# SERVICE BULLETIN

**BULLETIN # 04-04**  
**DATE: 5/24/2004**  
**SUBJECT: 34 Convertible Exhaust Tube Clearance**

**HULL #s: 101 to 159**

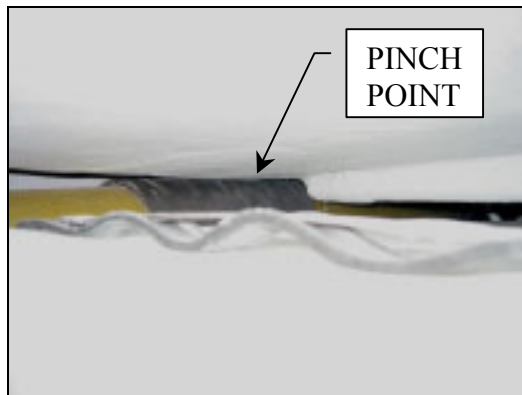
It has recently come to our attention that on some 34 Convertibles, there may be a problem with the main engine exhaust lines. On some installations, the FRP exhaust tube may be hitting on the underside of the cockpit floor. Over time, this may result in damage to and ultimate failure of the main engine exhaust lines. This can lead to a dangerous build-up of water, exhaust fumes, and carbon monoxide in the bilge of the boat.

In order to protect the exhaust lines, the following modifications must be made. Photographs have been included for further clarification:

- ∞ Open the cockpit hatch and remove the cockpit fish box.
- ∞ Using a flashlight, observe the exhaust tube on both the port and starboard side. Inspect the area to see if the tube is hitting the underside of the cockpit floor. The likely pinch point is approximately 3 ft. forward of the exhaust port
- ∞ Slice a 12" piece of soft-wall exhaust hose (5" on all gasoline boats and Yanmar 6LP-315Hp diesel boats, 6" on Cummins 330B diesel boats) in half lengthwise as shown in the photo below.

- ∞ Apply small amount of urethane caulk to the inside of each half of the hose (approx. two quarter sized dots, spaced 3” from the ends of the hose).
